**World Forum for Harmonization of Vehicle Regulations****Working Party on Passive Safety****Fifty-sixth session**

**Global technical regulation No. 9 (Pedestrian safety) – Proposal for Phase 2 of the global technical regulation****Draft amendment 2****Submitted by the Informal Working Group on global technical regulation No. 9\***

The text reproduced below was prepared by the experts of the Informal Working Group (IWG) on Global Technical Regulation No. 9 Phase 2 (GTR9-PH2) and proposes provisions on pedestrian safety and motor vehicles. It is based on ECE/TRANS/WP.29/GRSP/2013/25 and on GRSP-54-33-Rev.2 which was distributed without a symbol at the fifty-fourth session of the Working Party on Passive Safety (GRSP) (ECE/TRANS/WP.29/GRSP/54, paras. 7 and 8). The modifications to the text of the UN GTR are marked in bold for new or strikethrough for deleted characters.

"Figure 12  
**Flexible lower legform impactor: Dimensions and centre of gravity locations of femur, knee joint and tibia (side view)**

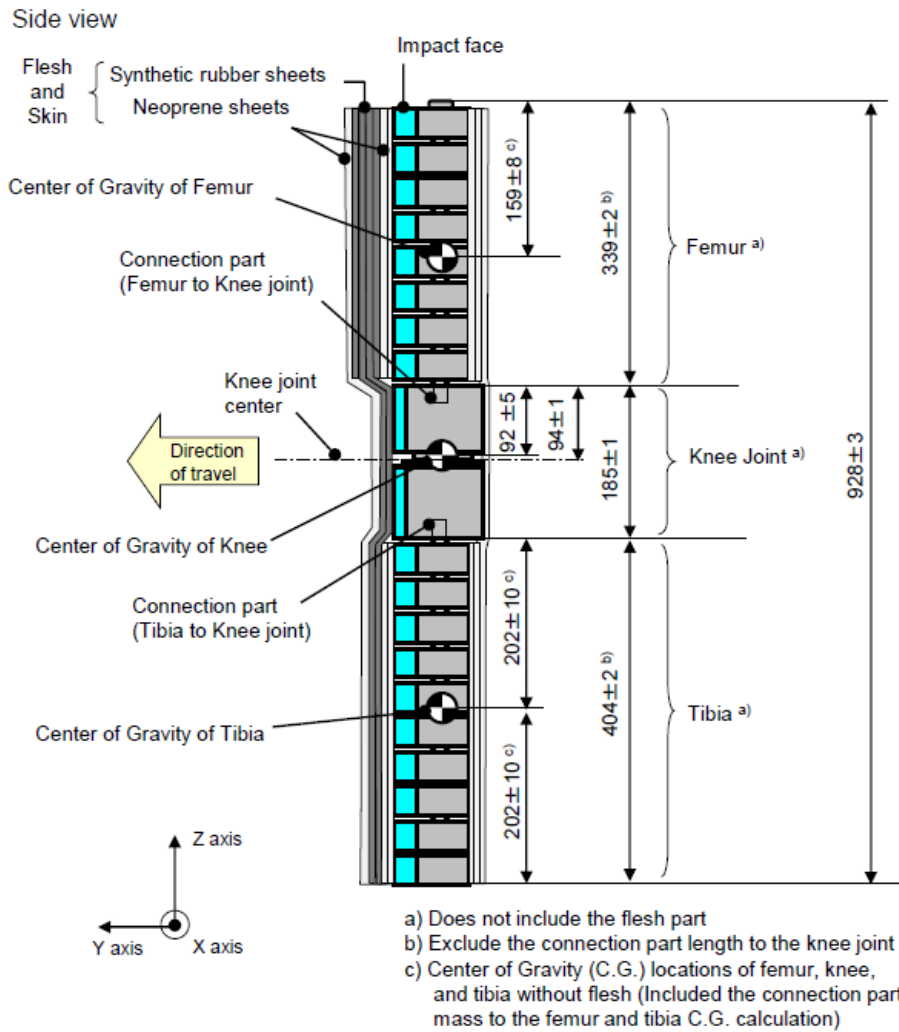
**The flexible lower legform impactor shall consist of the flesh and skin, the flexible long bone segments (representing the femur and the tibia), and the knee joint as shown in Figure 12.**

~~The lower legform impactor shall consist of two foam covered rigid segments, representing femur (upper leg) and tibia (lower leg), joined by a deformable, simulated knee joint. The overall length of the impactor shall be  $926 \pm 5$  mm, having a required test mass of  $13.4 \pm 0.2$  kg (see Figure 12).~~

~~Brackets, pulleys, etc. attached to the impactor for the purpose of launching it, may extend the dimensions shown in Figure 12.~~

The centres of gravity of the femur and tibia without the flesh and skin, including the connection parts to the knee joint, shall be  $159 \pm 8$  mm and  $202 \pm 10$  mm respectively from the top, but not including the connection part to the knee joint, of each part as shown in Figure 12. The centre of gravity of the knee joint shall be  $92 \pm 5$  mm from the top of the knee joint as shown in Figure 12.

Figure 13  
**Flexible lower legform impactor: Schematic plan views of femur, tibia, and knee dimensions (top view)**

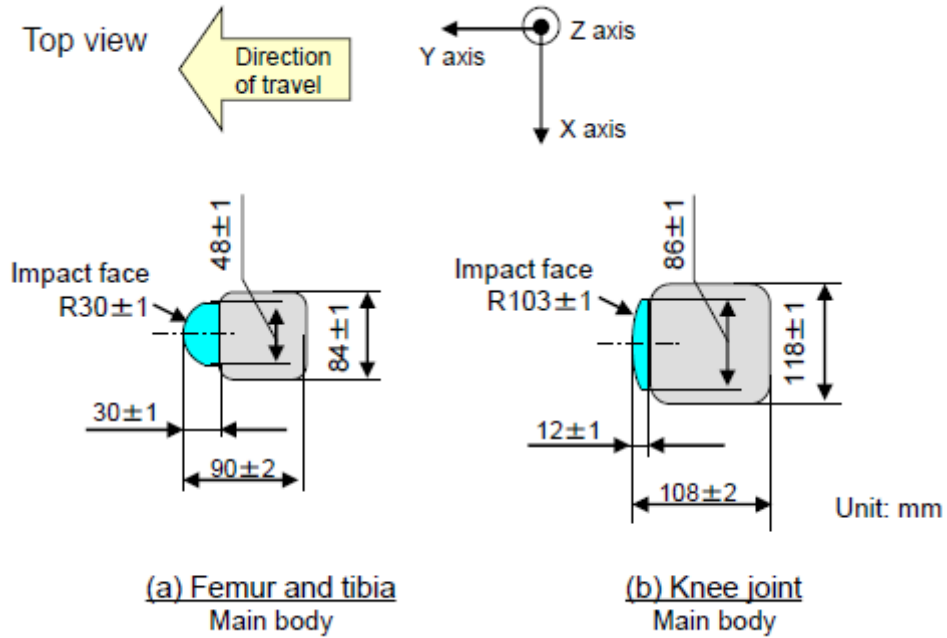
6.3.1.1.1. **The cross-sectional shape perpendicular to the Z-axis of the femur and the tibia main body segments shall be 90 mm in width along the Y-axis, and 84 mm in width along the X-axis as shown in Figure 13 (a). The impact face shall be 30 mm in radius, 30 mm in width along the Y-axis, and 48 mm in width along the X-axis as shown in Figure 13 (a).**

6.3.1.1.2. **The cross-sectional shape perpendicular to the Z-axis of the knee joint shall be 108 mm in width along the Y-axis, and 118 mm in width along the X-axis as shown in Figure 13 (b). The impact face shall be 103 mm in radius, 12 mm in width along the Y-axis, and 86 mm in width along the X-axis as shown in Figure 13 (b).**

Figure 14  
**Flexible lower legform impactor: Flesh and skin dimensions**

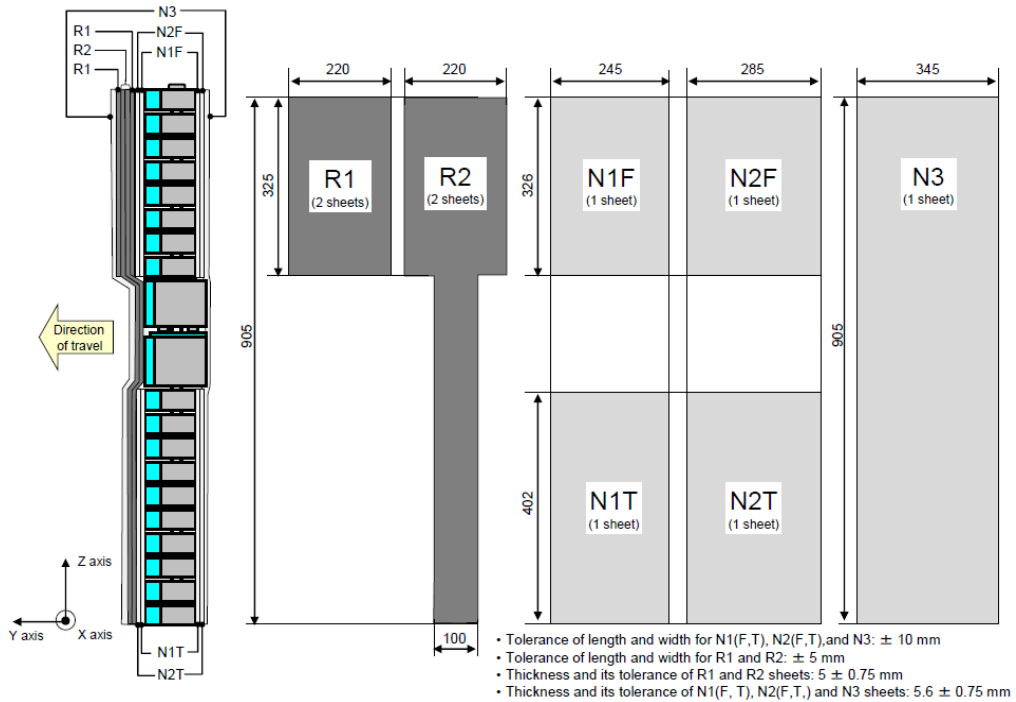
- 6.3.1.1.4. **For each test, the impactor (femur, knee joint and tibia) shall be covered by the flesh and skin composed of synthetic rubber sheets (R1, R2) and neoprene sheets (N1F, N2F, N1T, N2T, N3) as shown in Figure 14. The size of the sheets shall be within the requirements described in Figure 15. The sheets are required to have compression characteristics as shown in Figure 15. The compression characteristics shall be checked using material from the same batch as the sheets used for the impactor flesh and skin.**

~~For each test the impactor shall be fitted with new foam flesh cut from one of up to four consecutive sheets of foam type CF 45 flesh material or equivalent, produced from the same batch of manufacture (cut from one block or 'bun' of foam), provided that foam from one of these sheets was used in the dynamic certification test and the individual weights of these sheets are within  $\pm 2$  percent of the weight of the sheet used in the certification test.~~

"Figure 20

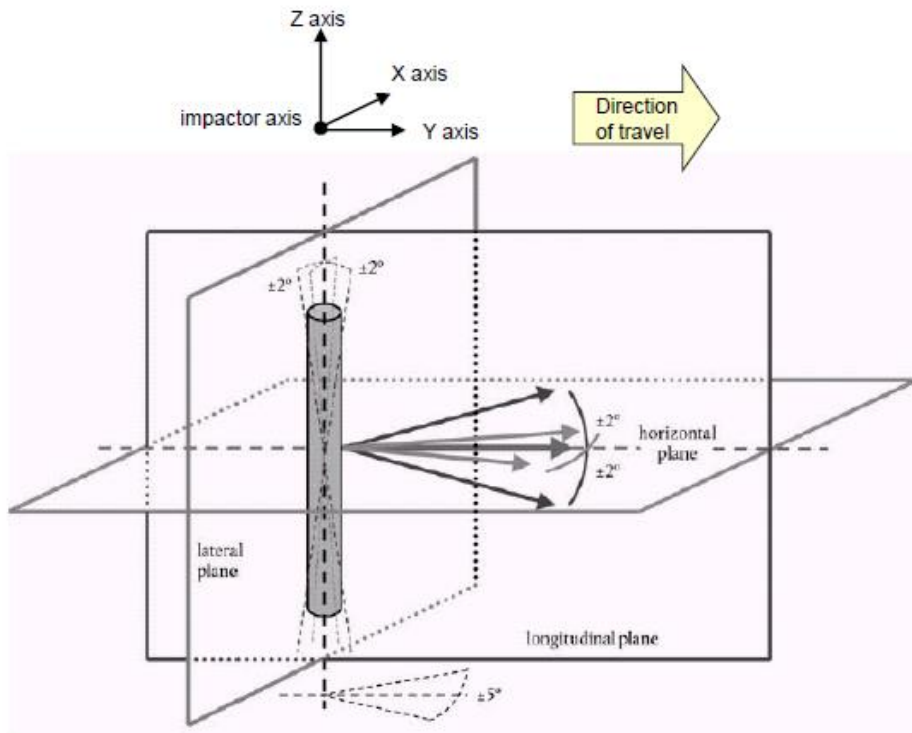
7.1.1.3.2. **At the time of first contact the impactor shall have the intended orientation about its vertical axis, for the correct operation of its knee joint, with a yaw angle tolerance of  $\pm 5^\circ$  (see Figure 20).**

~~At the time of first contact the impactor shall have the intended orientation about its vertical axis, for the correct operation of its knee joint, with a tolerance of  $\pm 5^\circ$  (see Figure 16).~~"

Figure 21

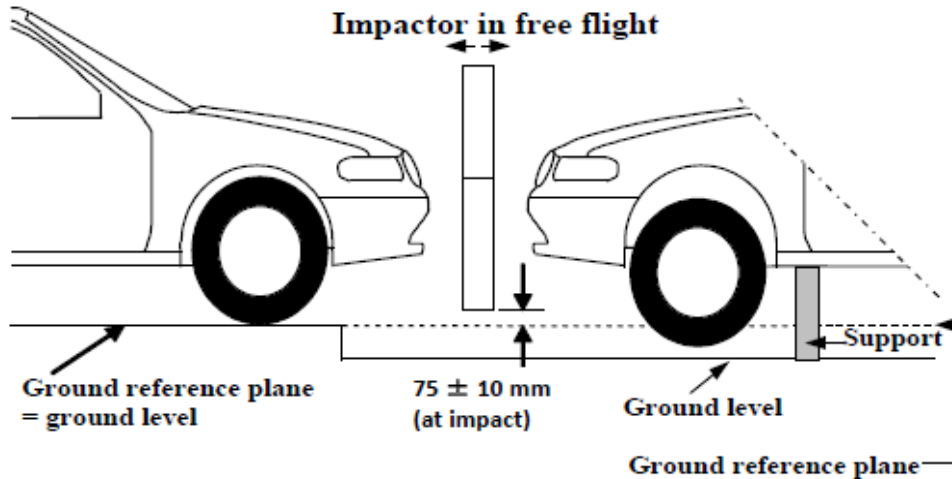
- 7.1.1.3. **The bottom of the impactor (without parts needed for the purposes of launching and/or protection) shall be 75 mm above the ground reference plane at the time of the first contact with the bumper (see Figure 21), with a tolerance of  $\pm 10$  mm. When setting the height of the propulsion system, an allowance must be made for the influence of gravity during the period of free flight of the impactor.**  
~~The bottom of the impactor shall be at 25 mm above ground reference plane at the time of first contact with the bumper (see Figure 17), with a  $\pm 10$  mm tolerance. When setting the height of the propulsion system, an allowance must be made for the influence of gravity during the period of free flight of the impactor.~~

**Flexible lower legform impactor: Requirement corridors of the femur and the tibia in the static certification test (see paragraph 8.1.1.2.)**

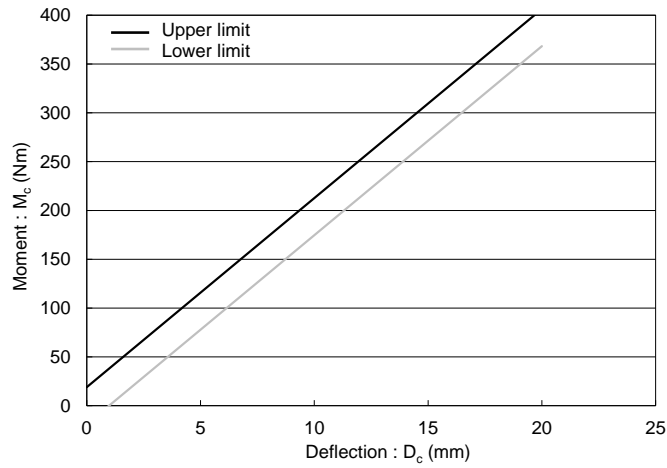
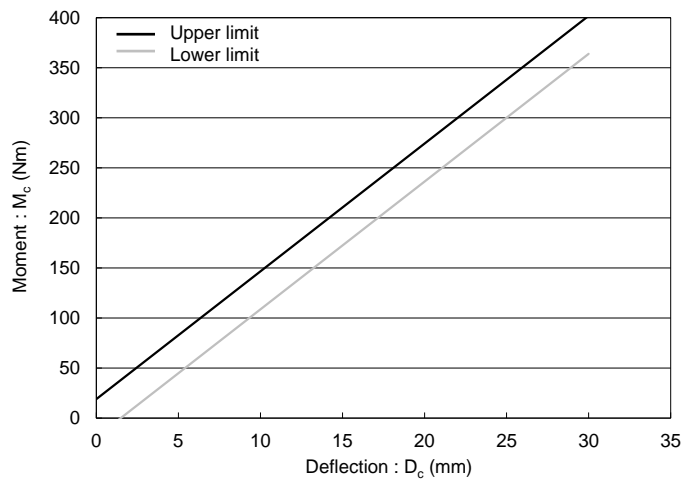
- 8.1.1.2. **When the femur and the tibia of the impactor are loaded in bending in accordance with paragraph 8.1.1.4., the applied moment and the generated deflection at the centre of the femur and the tibia ( $M_c$  and  $D_c$ ) shall be within the corridors shown in Figure 22.**

~~When the impactor is loaded in bending in accordance with paragraph 8.1.1.4., the applied force/bending angle response shall be within the limits shown in Figure 18. Also, the energy taken to generate  $15.0^\circ$  of bending shall be  $100 \pm 7$  J.~~

Figure 23  
**Flexible lower legform impactor: Requirement corridors for the knee joint in the static certification test (see paragraph 8.1.1.3.)**

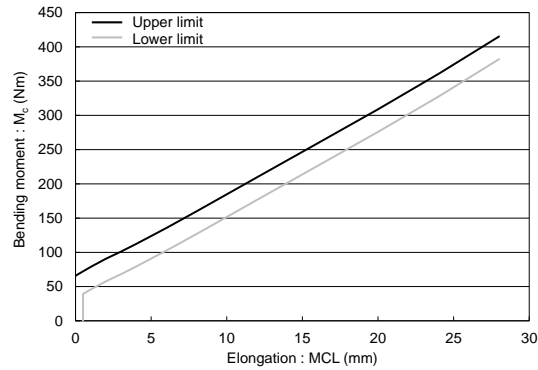
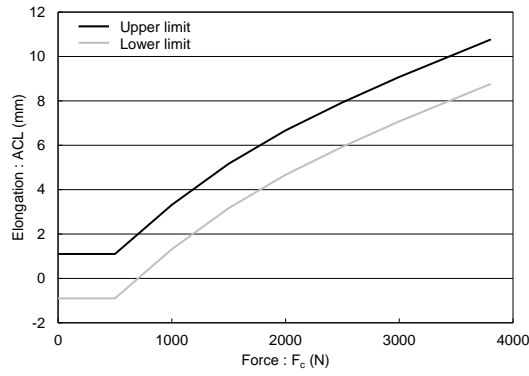
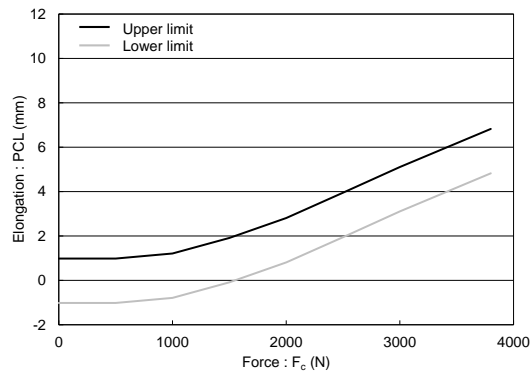
- 8.1.1.3. **When the knee joint of the impactor is loaded in bending in accordance with paragraph 8.1.1.5., the MCL, ACL, and PCL elongations and applied bending moment or the force at the centre of the knee joint ( $M_c$  or  $F_c$ ) shall be within the corridors shown in Figure 23.**

~~When the impactor is loaded in shearing in accordance with paragraph 8.1.1.5., the applied force/shearing displacement response shall be within the limits shown in Figure 19.~~

Figure 24  
**Flexible lower legform: Impactor test set-up for the femur in the static certification test (see paragraph 8.1.1.4.)**

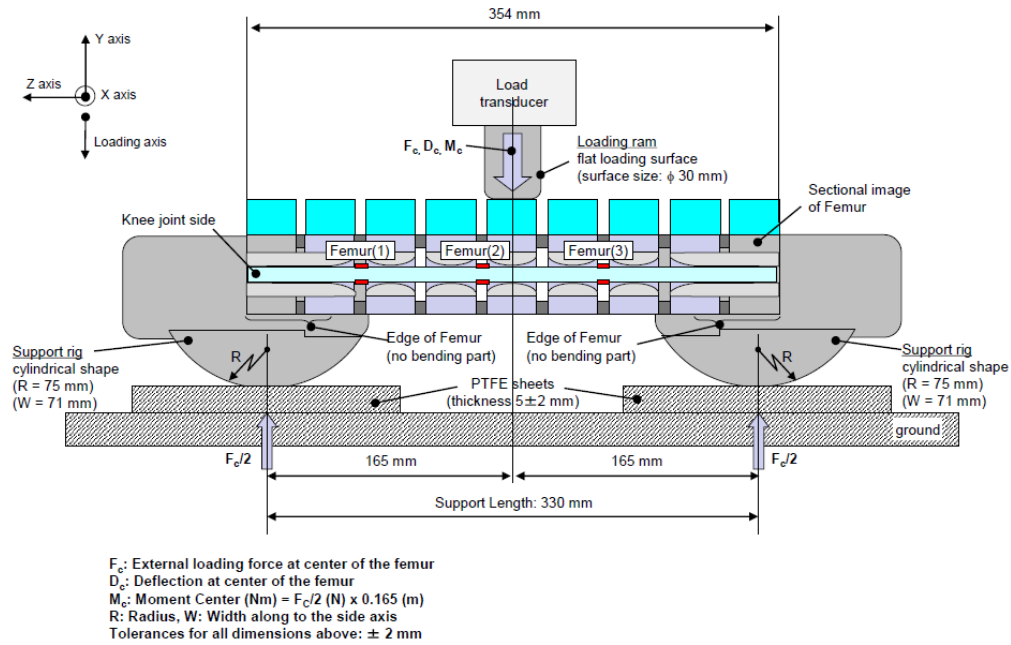
- 8.1.1.4. **The edges of the femur and tibia, not bending parts, shall be mounted to the support rig firmly as shown in Figure 24 and Figure 25. The Y-axis of the impactor shall be parallel to the loading axis within  $180 \pm 2^\circ$  tolerance. To obtain repeatable loading, low friction Polytetrafluoroethylene (PTFE) plastic pads are used under each support (see Figures 24 and 25).**

~~The impactor, without foam covering and skin, shall be mounted with the tibia firmly clamped to a fixed horizontal surface and a metal tube connected firmly to the femur, as shown in Figure 20. The rotational axis of impactor knee joint shall be vertical. To avoid friction errors, no support shall be provided to the femur section or the metal tube. The bending moment applied at the centre of the knee joint, due to the mass of the metal tube and other components (excluding the legform itself), shall not exceed 25 Nm.~~

Figure 26  
**Flexible lower legform impactor: Test set-up for the knee joint in the static certification test (see paragraph 8.1.1.5.)**

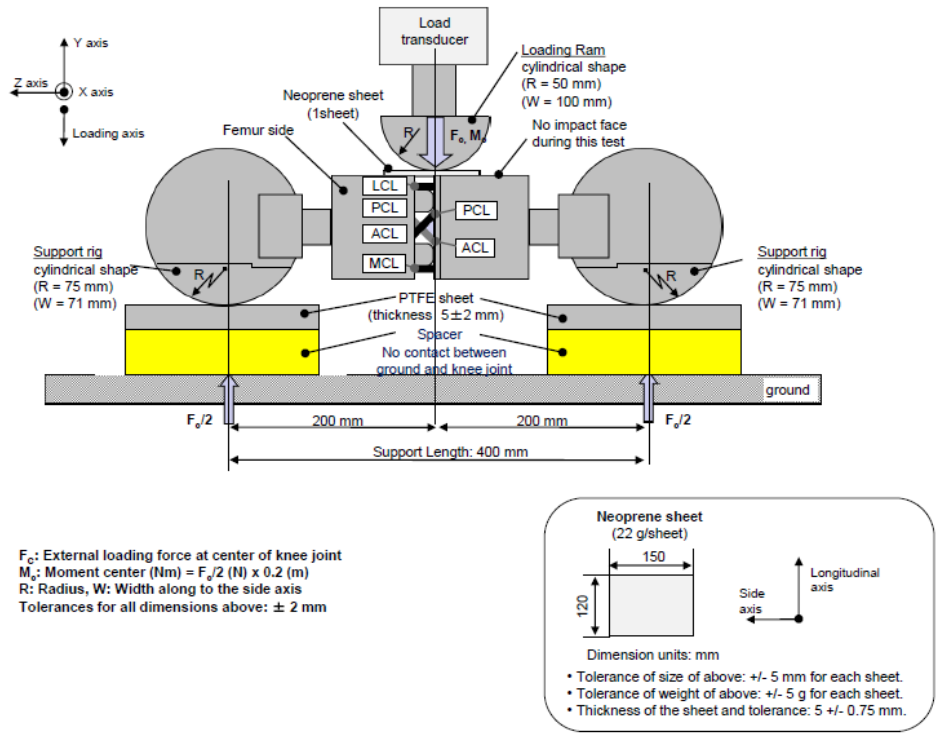
- 8.1.1.5. **The ends of the knee joint shall be mounted to the support rig firmly as shown in Figure 26. The Y-axis of the impactor shall be parallel to the loading axis within ± 2° tolerance. To obtain repeatable loading, low friction Polytetrafluoroethylene (PTFE) plastic pads are used under each support (see figure 26). To avoid impactor damage, a neoprene sheet shall be set underneath the loading ram and the impactor face of the knee joint which is described in the Figure 13 shall be removed. The neoprene sheet used in this test shall have compression characteristics as shown in Figure 15.**

**The centre of the loading force shall be applied at the knee joint centre within ± 2°mm tolerance along the Z-axis (see figure 12). The external load shall be increased so as to maintain a deflection rate between 10 and 100 mm/minute until the bending moment at the centre part of the knee joint ( $M_c$ ) reaches 400 Nm.**

~~The impactor, without foam covering and skin, shall be mounted with the tibia firmly clamped to a fixed horizontal surface and a metal tube connected firmly to the femur and restrained at 2.0 m from the centre of the knee joint, as shown in Figure 21.~~

Figure 27  
**Flexible lower legform impactor: Test set-up for the dynamic lower legform impactor certification test (pendulum test, see paragraph 8.1.2.4.)**

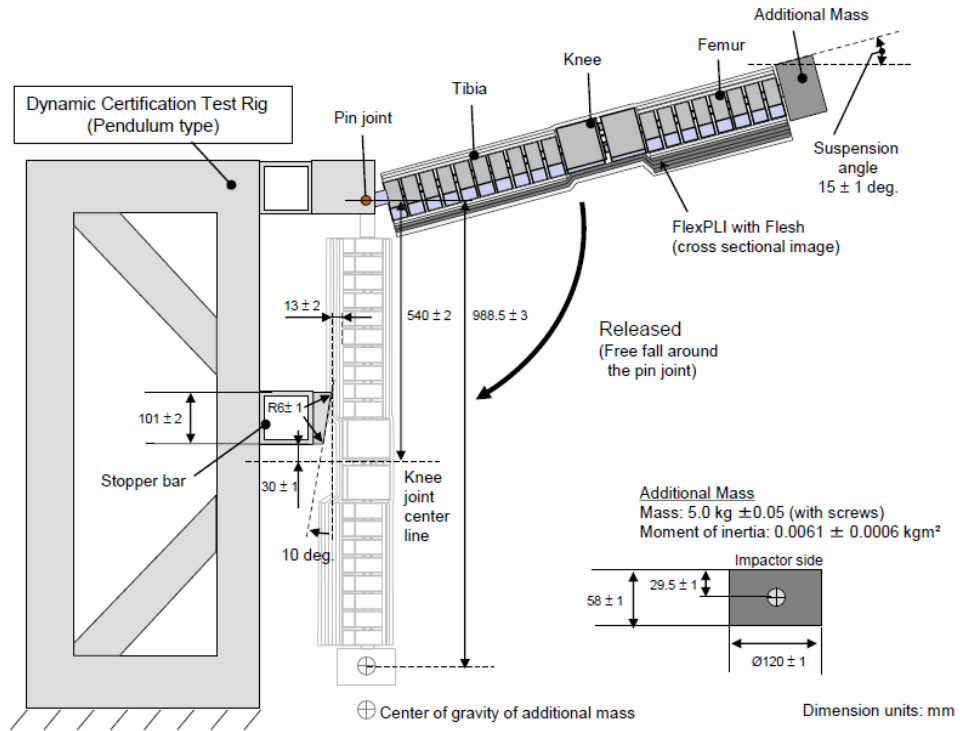
- 8.1.2.4.1. **The flexible lower legform impactor, including the flesh and skin, shall be suspended from the dynamic certification test rig  $15 \pm 1^\circ$  upward from the horizontal as shown in Figure 27. The impactor shall be released from the suspended position and fall freely against the pin joint of the test rig as shown in Figure 27.**

~~The impactor, including foam covering and skin, shall be suspended horizontally by three wire ropes of  $1.5 \pm 0.2$  mm diameter and of 2000 mm minimum length, as shown in Figure 22. It shall be suspended with its longitudinal axis horizontal, with a tolerance of  $\pm 0.5^\circ$ , and perpendicular to the direction of the certification impactor motion, with a tolerance of  $\pm 2^\circ$ . The impactor shall have the intended orientation about its longitudinal axis, for the correct operation of its knee joint, with a tolerance of  $\pm 2^\circ$ . The impactor must meet the requirements of paragraph 6.3.1.1., with the attachment bracket(s) for the wire ropes fitted.~~

- 8.1.2.4.2. **The knee joint centre of the impactor shall be  $30 \pm 1$  mm below the bottom line of the stopper bar, and the tibia impact face without the flesh and skin shall be located  $13 \pm 2$  mm from the front upper edge of the stopper bar when the impactor is hanging freely as shown in Figure 27.**

~~The certification impactor shall have a mass of  $9.0 \pm 0.05$  kg, this mass includes those propulsion and guidance components which are effectively part of the impactor during impact. The dimensions of the face of the certification impactor shall be as specified in Figure 23. The face of the certification impactor shall be made of aluminium, with an outer surface finish of better than 2.0 micrometers.~~

Figure 28  
**Flexible lower legform impactor: Test set-up for the dynamic lower legform impactor certification test (inverse test, see paragraph 8.1.3.4.)**

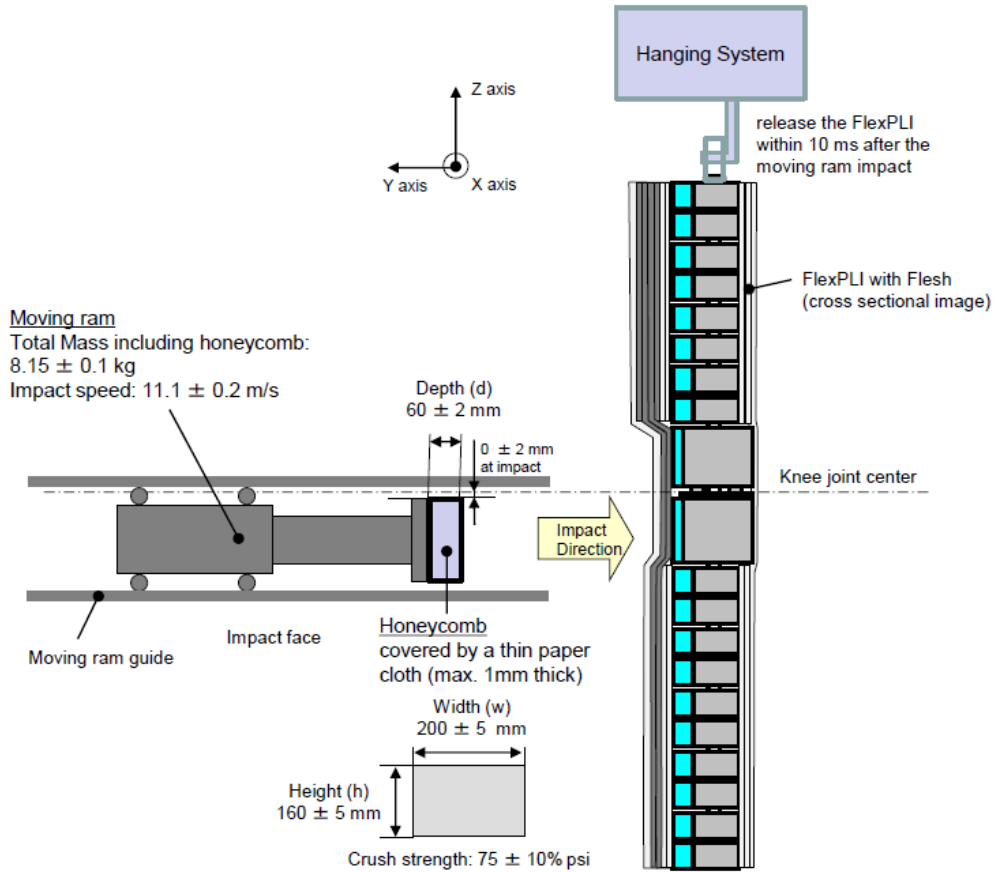
- 8.1.3.4. Test procedure
- 8.1.3.4.1. The assembled flexible lower legform impactor (with the flesh and skin) shall be hung vertically and freely suspended from a test rig as shown in Figure 28. It is then impacted by the upper edge of a linearly guided aluminium honeycomb impactor, covered by a thin paper cloth with a maximum thickness of 1 mm, at an impact speed of  $11.1 \pm 0.2$  m/s. The legform shall achieve a free flight condition within 10 ms after the time of first contact of the honeycomb impactor.

- 8.1.3.4.4. At the time of the first contact, the flexible lower legform impactor pitch angle (rotation around the Y-axis) and, therefore, the pitch angle of the velocity vector of the honeycomb impactor shall be within a tolerance of  $\pm 2^\circ$  in relation to the lateral vertical plane. The flexible lower legform impactor roll angle (rotation around the X-axis) and, therefore, the roll angle of the honeycomb impactor shall be within a tolerance of  $\pm 2^\circ$  in relation to the longitudinal vertical plane. The flexible lower legform impactor yaw angle (rotation around the Z-axis) and, therefore, the yaw angle of the velocity vector of the honeycomb impactor shall be within a tolerance of  $\pm 2^\circ$ .
